**Service Bulletin**

No.: MZ08-052

Model: MM8003

**Subject:** The supplier of the (BALANCE INPUT PWB) XLR female connectors has been changed.

JK50/JK51/JK60/JK61/JK70/JK71/JK80/JK81

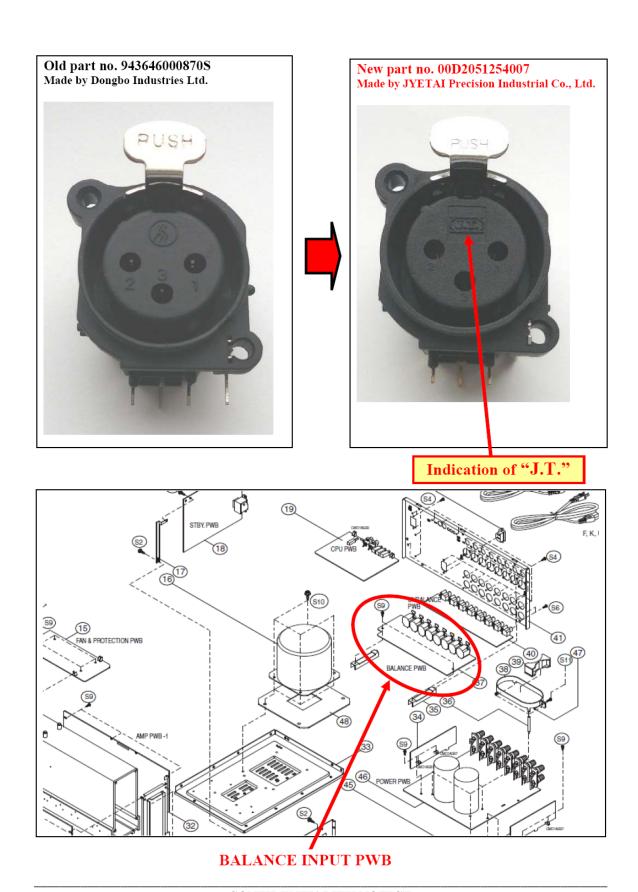
**Symptom:** Due to the XLR cable (male connector) varying in quality and also due to wear, some XLR female jacks manufactured by Dongbo Industries Ltd are not tight enough to lock when the XLR connectors are inserted.

**Solution:** Replacement parts for POS NO. <u>JK50/JK51/JK60/JK61/JK70/JK71/JK80/JK81</u> (BALANCE INPUT PWB) XLR female connectors will be switched from Dongbo Industries Ltd to Jyetai Precision Industrial Co., Ltd..
